1984 Corvette: Service Bulletin: No Heat - A/C Control Unit

Source: Chevrolet Dealer Service Technical Bulletin

Bulletin Number: 83-T-70, Number Ia

Date: August, 1983

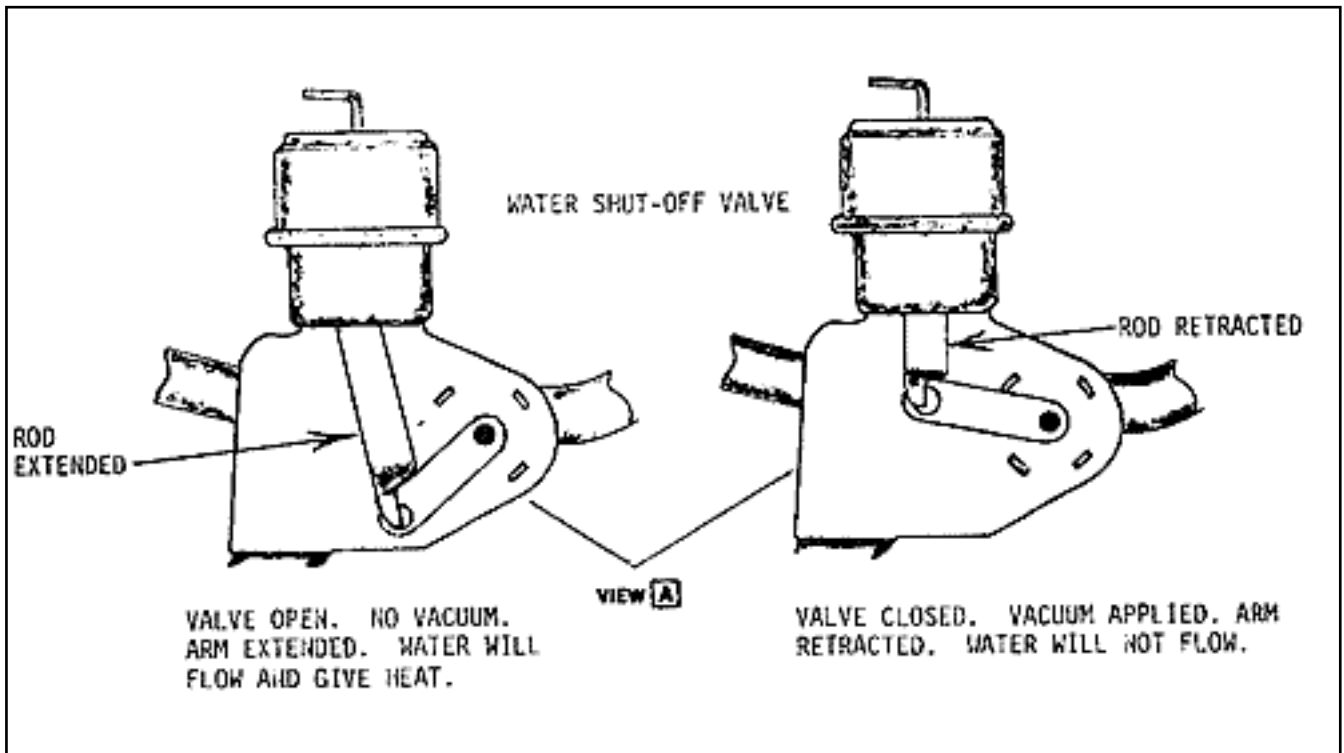
The vacuum switch in the A/C control unit controls a water shut off valve on the evaporator blower assembly. This valve should be closed with the temperature selector lever in the full cold position and open with the lever in any other position. Water will not flow through the heater core when the valve is closed (vacuum applied). Note that the valve actuating rod will be extended when the valve is open and retracted when closed (refer to sketch).

On vehicles, built prior to April, 1983, the following procedure is recommended to resolve this "no heat" condition:

1. Observe the operation of the valve on the blower assembly while the temperature selector lever is moved from "cold" to "hot" position. The engine must be running to supply vacuum and should be at operating temperature.
2. If the valve opens (rod extended) when the temperature selector lever is moved to the "hot" position and heat output does not occur, the condition is not directly related to this particular control unit problem and should be further diagnosed, as described in Chevrolet Service Manual, Section 1.

3. If the valve does not open (rod retracted) remove the vacuum line from the valve. If this causes the valve to open and results in heat output, refer to Step 4.
4. Leave the vacuum line off the valve and seal off the end of the line to prevent a vacuum leak. (This can be done by fabricating a rubber plug or equivalent.) Secure the loose line to the harness with a band strap.
5. The vehicle can be operated with this line disconnected from the valve with no adverse effect to the A/C system.
